IWGMU proposal for R117 C2 noise temperature correction update

GRBP - 78th session

Proposal for R117 C2 non 3PMSF temperature correction update

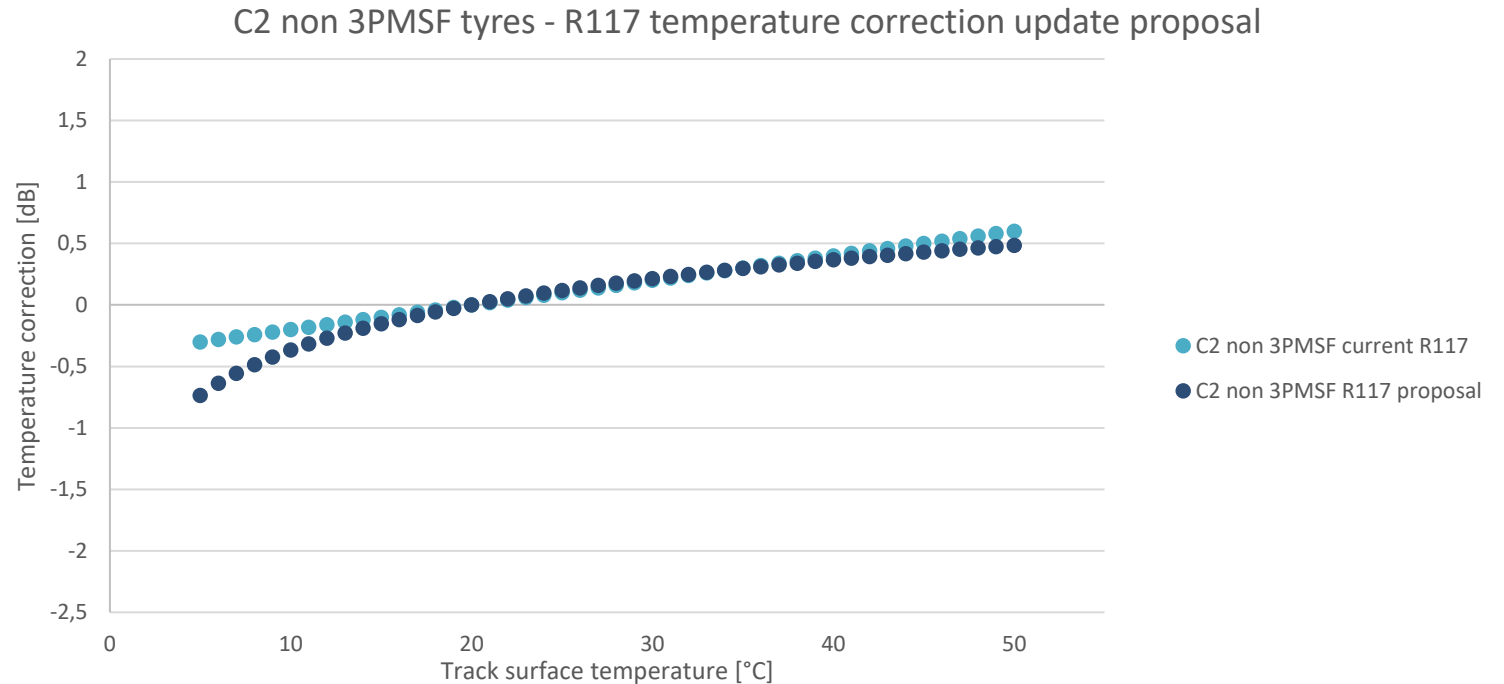
ETRTO proposal for R117 C2 non 3PMSF tyres, based on the collected data:

- **Introducing a logarithmic shape - temperature correction equation**, to better represent the low temperature sensitivity of non 3PMSF C2 tyres

$$L_{corr} = -K1 \times LOG \left(\frac{\vartheta_{ref} + K2}{\vartheta_{test} + K2} \right)$$

Non 3PMSF
K1	1,22
K2	0
ϑ_{ref}	20

C2 3PMSF tyres - R117 temperature correction update proposal

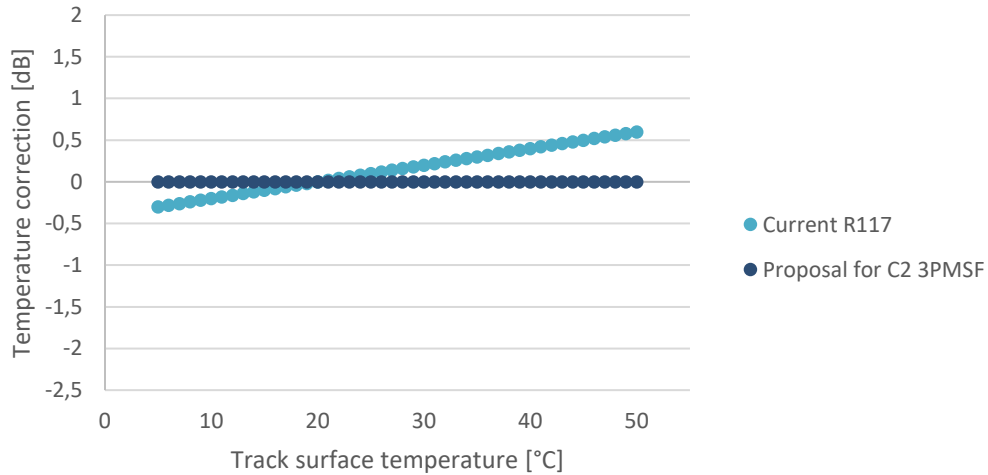
- C2 3PMSF tyres show such low temperature sensitivity that no temperature correction can be derived.

3PMSF
K1	0
K2	0
ϑ_{ref}	20
